Reg. Bus Gating	
TITLE: M8300B	
Document Number:	REV: E
Date: 10/8/2020 4:23:31 PM	Sheet: 1/3

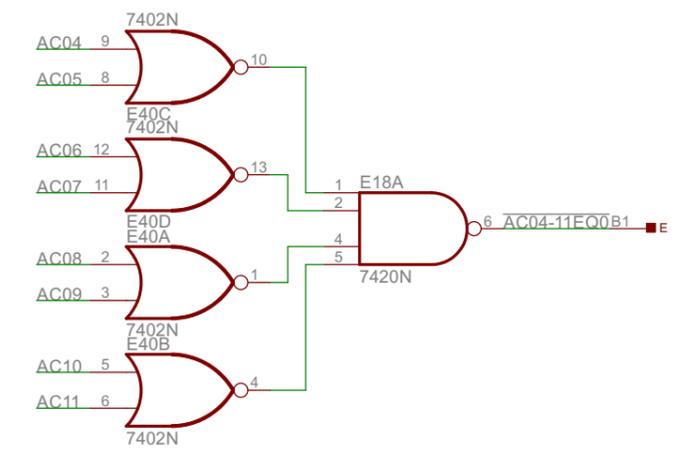
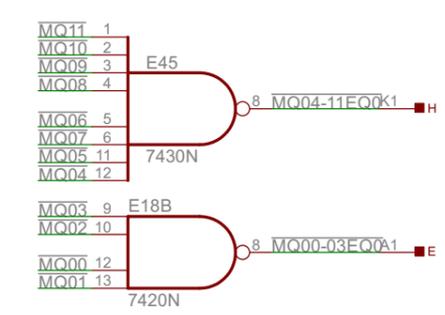
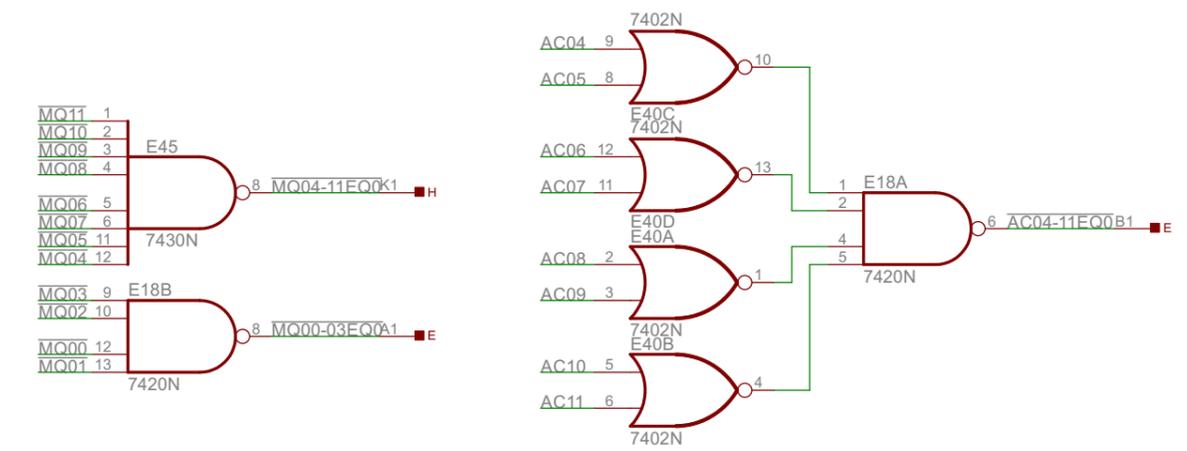
Contrary to DEC drawings:
 CC2 is not grounded, but DN2 is.
 DN1 is not grounded.
